100G SR4 Link Model Update, TDP, Tx Eye Mask & SRS

John Petrilla: Avago Technologies

July 2013

- 97 see page 18
- 98 see pages 19 & 20
- 100 see page 6
- 103 see pages 8, 12,13,14 &15

Figure 2

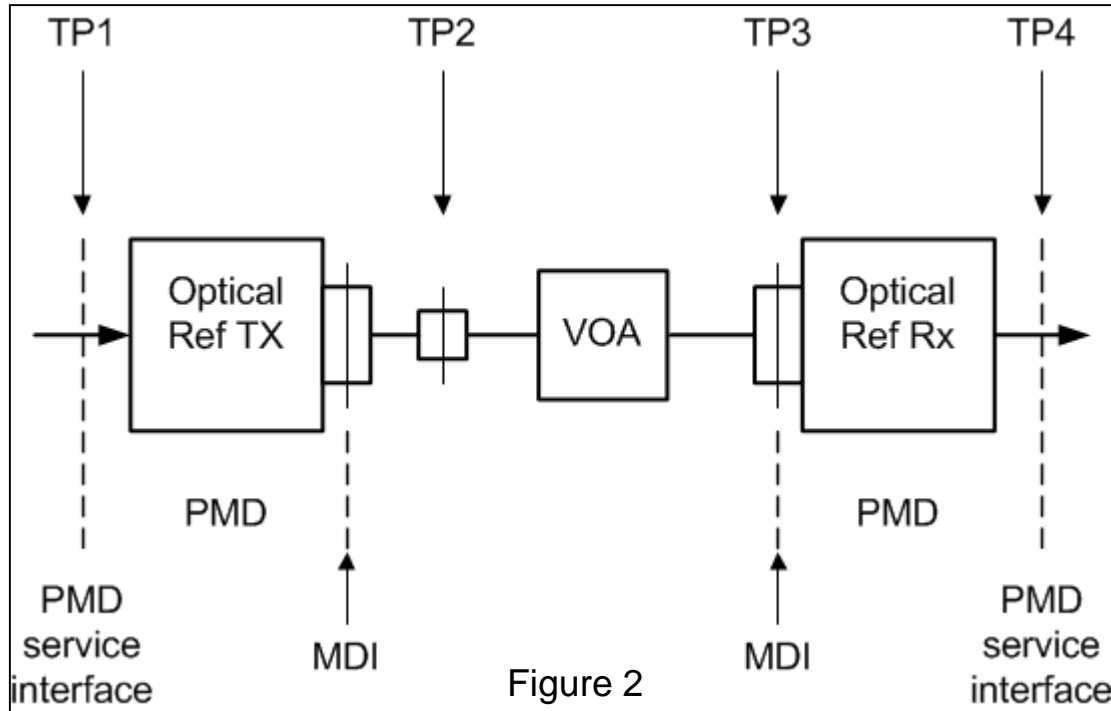
- 1) In setup of Figure 2, adjust VOA to yield TP4 TJ requirement. ([Comment 103](#))
- 2) Measure OMA at TP3.
- 3) Determine residual link penalty if any.
- 4) Record OMA - residual link penalty as Test Reference Sensitivity, S.

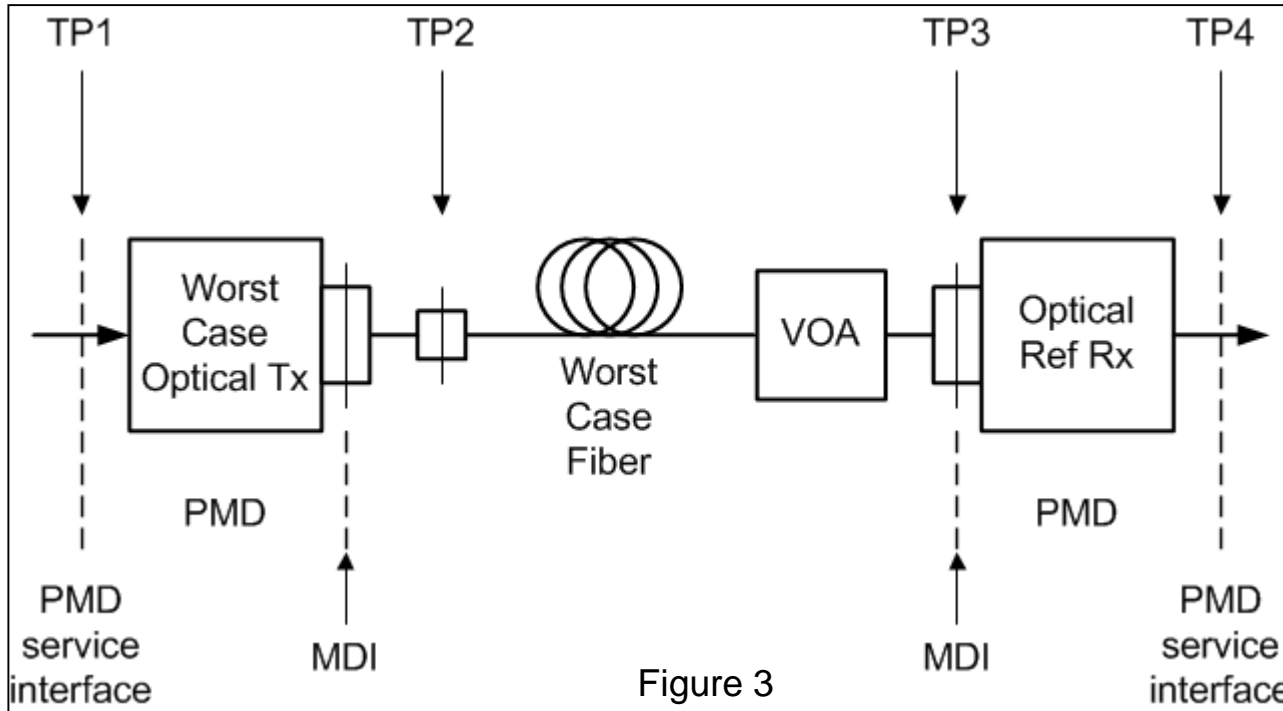
- 1) Replace Ref Tx in Figure 2 with Worst Case Tx, worst case TP1 conditions and Worst Case Fiber as shown in Figure 3.
- 2) Adjust VOA to yield TP4 TJ requirement. ([Comment 103](#))
- 3) Record OMA at TP3
- 4) Max TDP = OMA – Ref Rx S.

- Now that the sensitivity, S , of the Ref Rx has been established, the Ref Tx and reference channel is replaced by the worst case Tx operating with the worst case TP1 conditions and the worst case optical channel. This channel includes a VOA that is adjusted such that the requirements at TP4 are met.
- The difference between the signal level at TP3 for this case and S yields the **max limit for TDP, here 4.96 dB**.

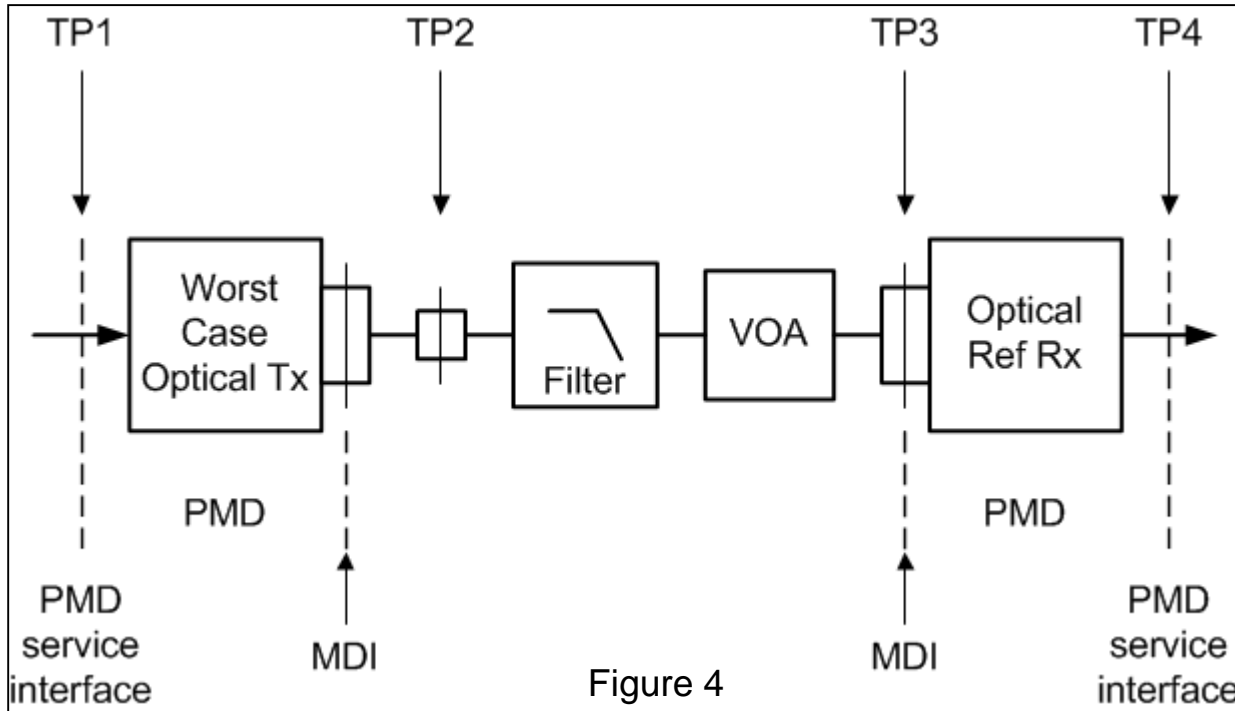
- 1) Replace Worst Case Fiber in Figure 3 with filter.
- 2) Adjust the VOA and Filter bandwidth to yield the same OMA at TP3, the same TP4 TJ and same total link penalties as seen in the setup of Figure 3. ([Comment 103](#))
- 3) Combine the bandwidth of the filter and Ref Rx and record as the Rx BW for the TDP measurement.

- Finally, the worst case channel is replaced by the reference channel and a filter is added to the Ref Rx input with a bandwidth that yields the same P_{total} central (link model cell T28) as did the worst case channel.
- Since the filter does not capture mode partition noise, $k(MPN)$ is set to 0 when determining the filter bandwidth (as is P_{mn} and the baseline wander coefficient).
- For the example link model, **this filter in combination with the Ref Rx yields a BW of 12.613 GHz.**

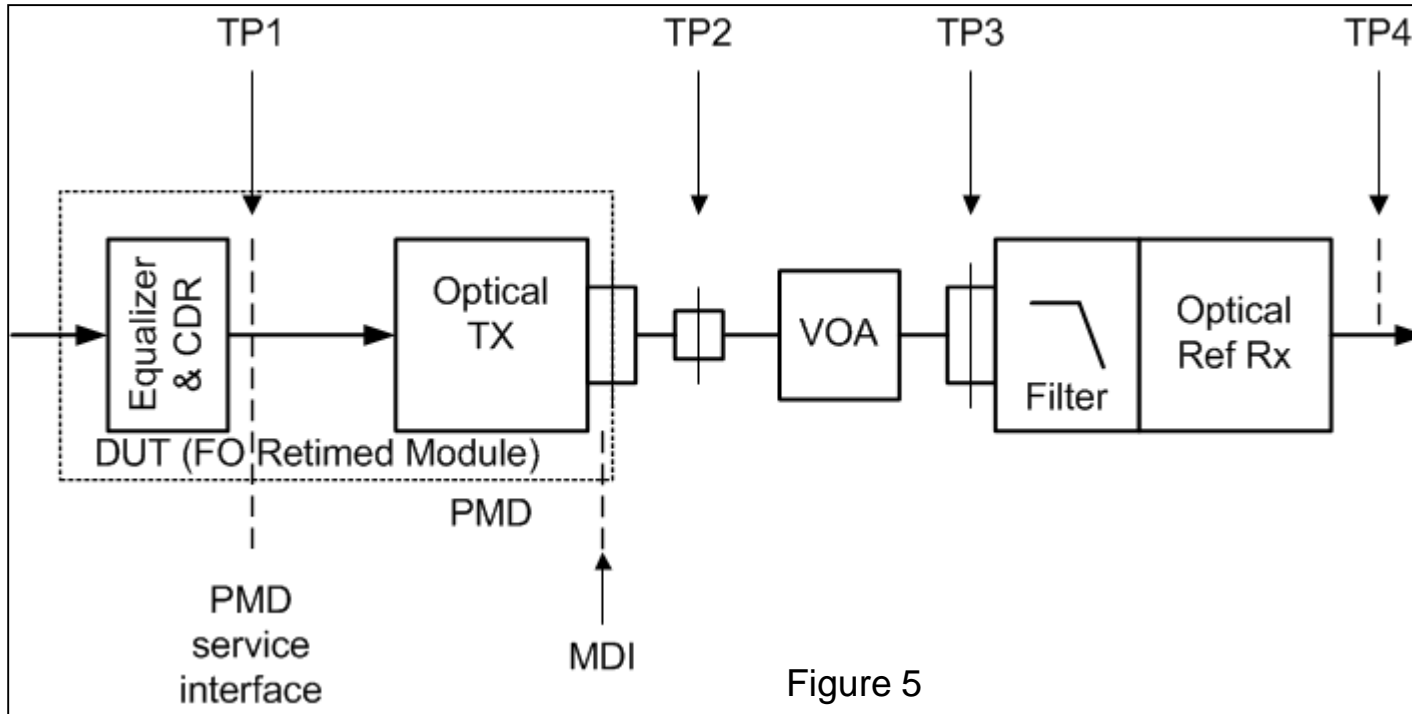
- 1) Replace Worst Case Tx in Figure 4 with Tx DUT as shown in Figure 5.
- 2) Adjust the VOA to yield the same OMA at TP3, the same TP4 TJ and same total link penalties as seen in the setup of Figure 3. [\(Comment 103\)](#)
- 3) Note the filter has been combined with the Ref Rx.

For the case where the ideal Tx in Figure 2, is used to calibrate the sensitivity of the combination of filter and Optical Ref Rx, i.e. a Ref Rx with a BW of 12.613 GHz instead of 19.336 GHz, a TDP penalty of 2.15 dB (all ISI) would be incurred.

100G SR4: Developing Tx Eye Mask Requirements

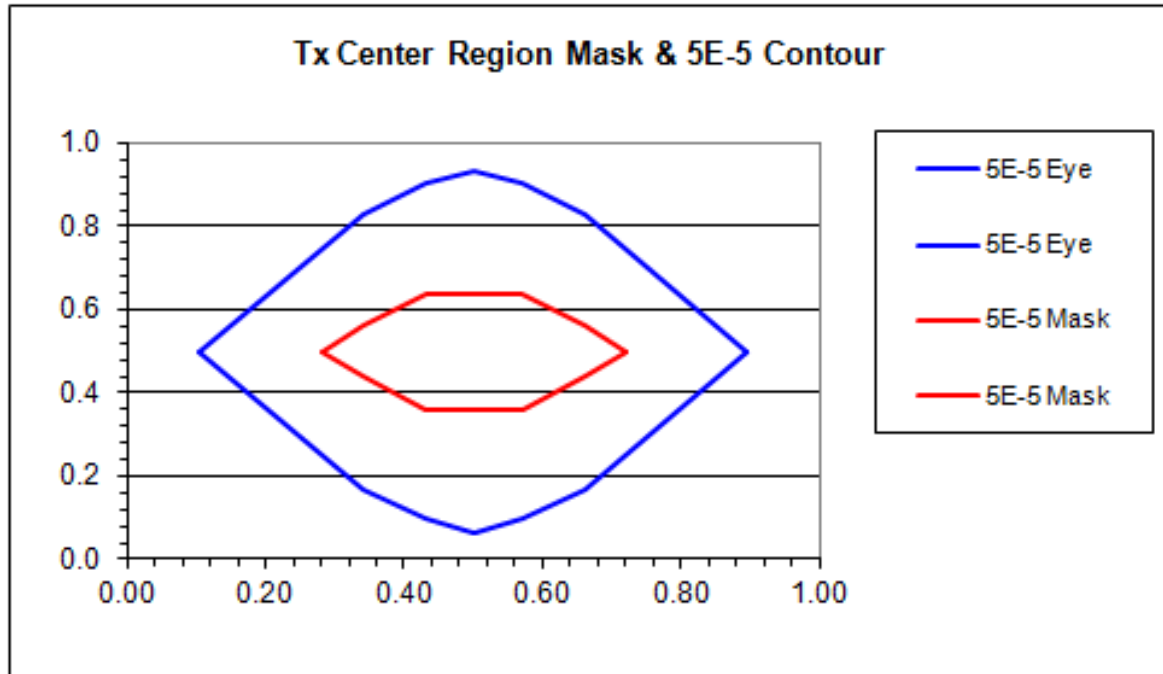
- Proposed mask coordinates are $X1 = 0.28$ UI, $X2 = 0.34$ UI, $X3 = 0.43$ UI, $Y1 = 0.36$ UA, $Y2 = 0.44$ UA, $Y3 = 0.40$ UA**
- These coordinates are not the same as found in comment 97. The model used to generate jitter contours when preparing comment 97 was not properly updated for BER and yielded inaccurate results. These should replace the coordinates proposed in comment 97.

100G SR4: Developing SRS Requirements

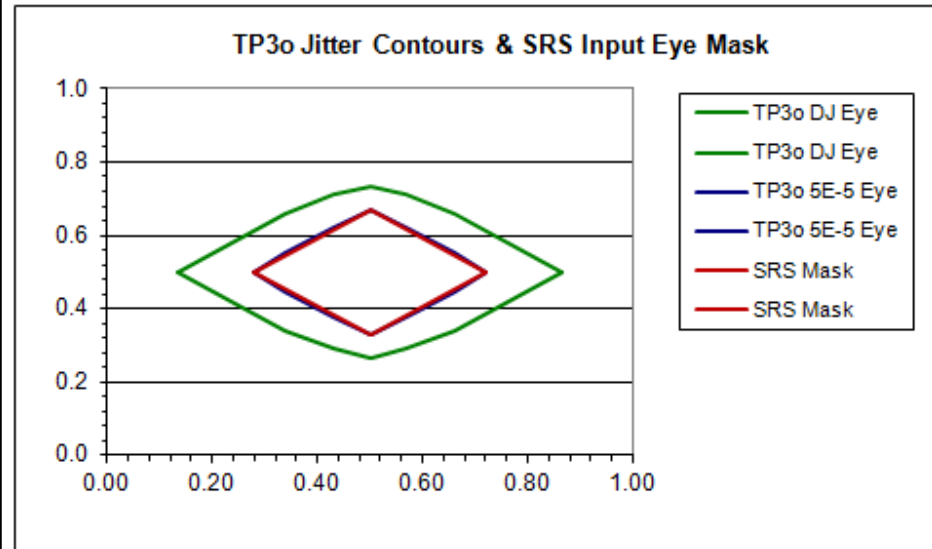
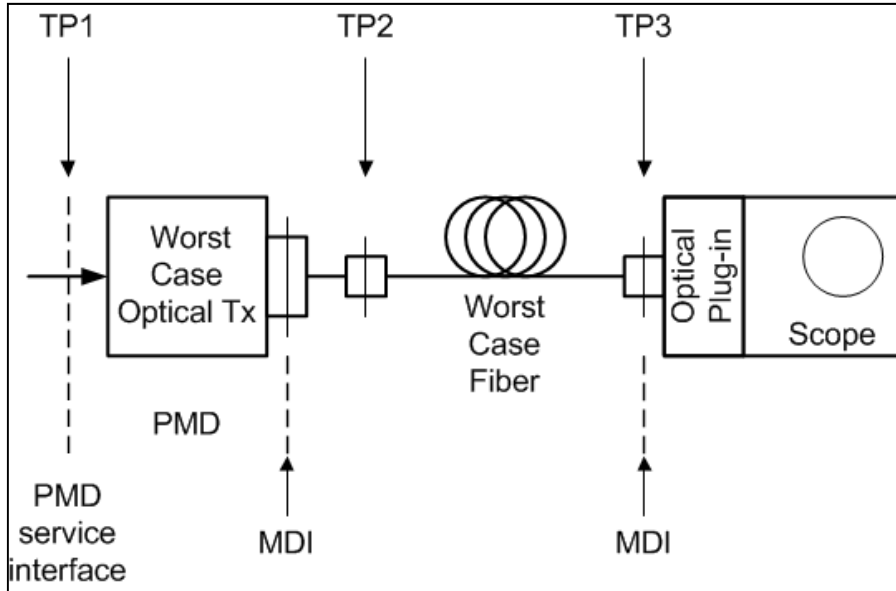
- As with determining the coordinates for the Tx eye mask, a link model can be setup to determine stressed receiver conditions that represent the worst case conditions expected at TP3.
- Here the worst case fiber including maximum connector loss is inserted between the worst case Tx and scope used to observe the jitter contours at TP2.
- In the above right chart, two jitter contours are shown and it can be seen that the 5E-5 contour approaches a diamond shape. At the center of the eye, the height of the DJ eye corresponds to a VECF of 3.3 dB.
- A diamond shaped mask can be seen as a fair approximation of the 5E-5 contour.
- Coordinates for the proposed 5E-5 SRS input eye mask are $X1 = 0.28 \text{ UI}$, $X2 = 0.5 \text{ UI}$, $X3 = 0.5 \text{ UI}$, $Y1 = 0.33 \text{ UA}$, $Y2 = 0.33 \text{ UA}$, $Y3 = 0.4 \text{ UA}$. (Comment 98)
